DESIGN REVIEW RECOMMENDATION

SDCI #3040275-LU
6102 14th Ave NW
Seattle, WA 98107

Applicant:
Cone Architecture
1319 N 49th Street
Seattle, WA 98103
Contact: Emily Terzic

PEDESTRIAN VIEW ALONG NW 61ST ST

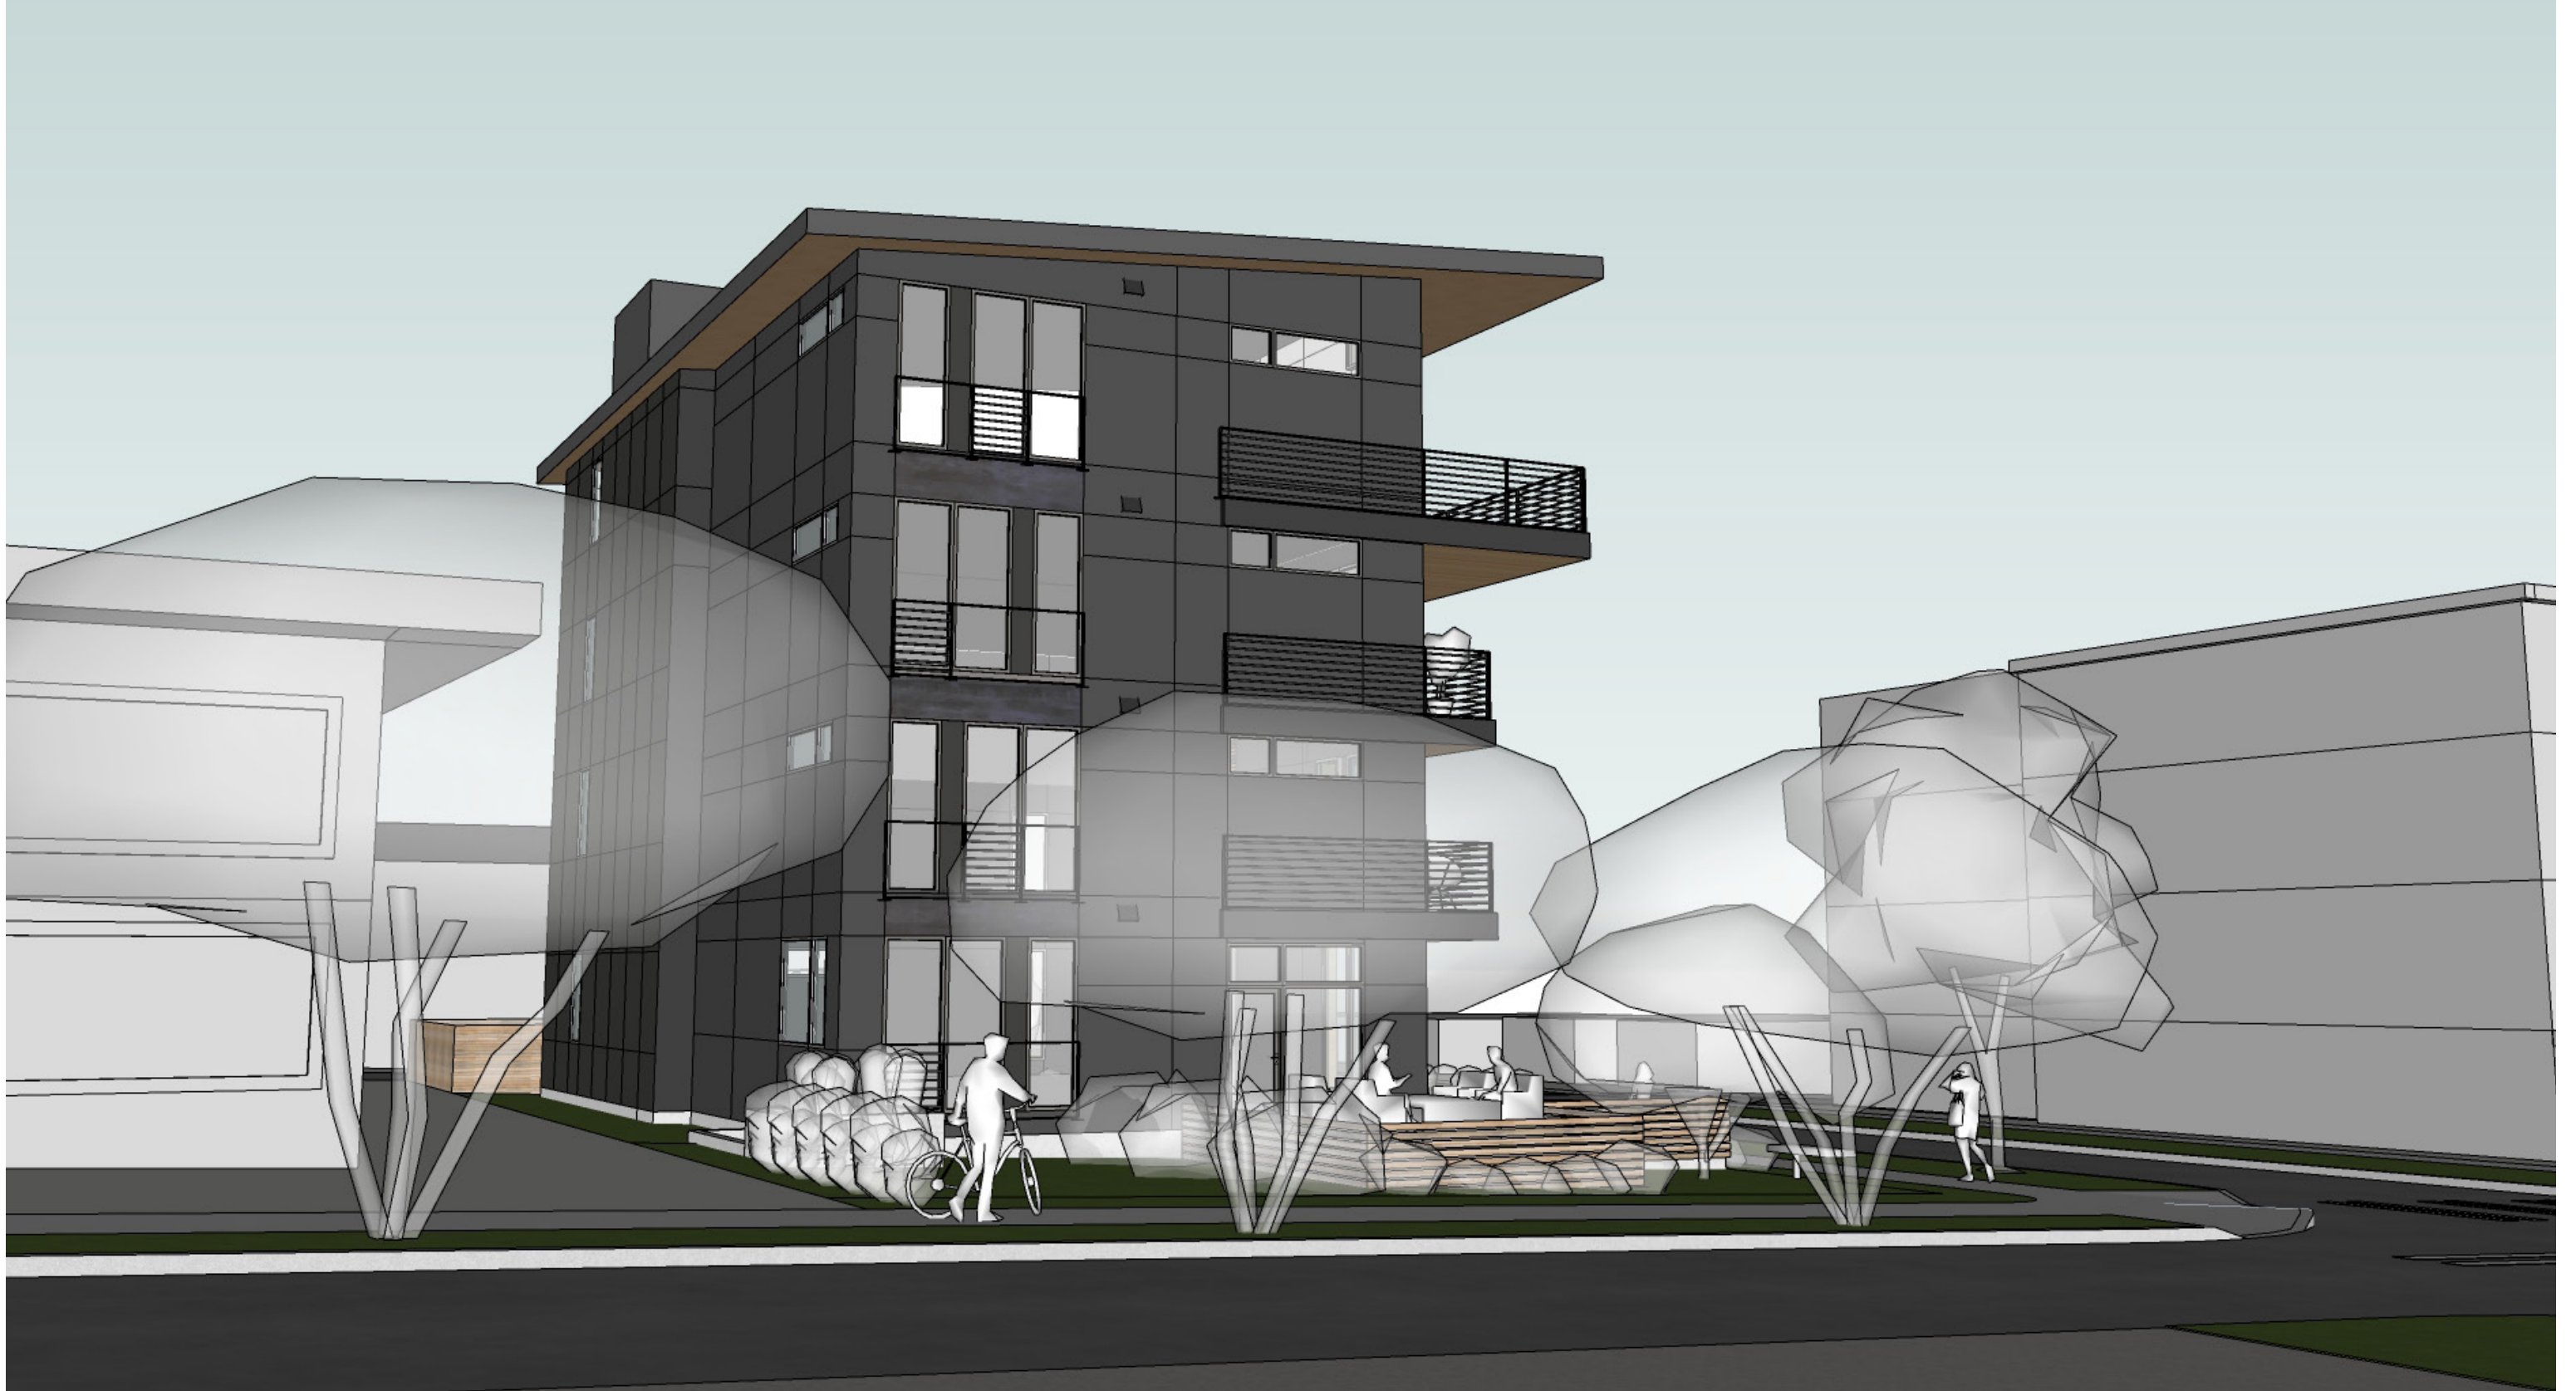
The Board emphasized the need for secondary architectural features to aid in the reduction of the building scale (CS2-D. Height, Bulk, and Scale, CS3-A-4. Evolving Neighborhoods, DC2-B-1. Façade Composition, DC2-C. Secondary Architectural Features).

A simple material palette composed of a variety of smooth and textured high quality fiber cement panel with warm wood accents, relating to the neighboring material context, is proposed. The various panel types interact through playful material breaks and infill moments.

Juliet balconies at the south and west facades add texture to the overall composition of the building. To further reduce the building scale, the fourth level deck has been combined with a fin wall to engage the street, providing overhead weather protection for the residential entry. Two additional decks have been added below the fourth floor deck, following contextual patterns, and reducing the bulk of the overall form.

Cedar soffits are proposed to provide a sense of warmth from the pedestrian view, while also balancing the monochromatic nature of the smooth and textured panel.
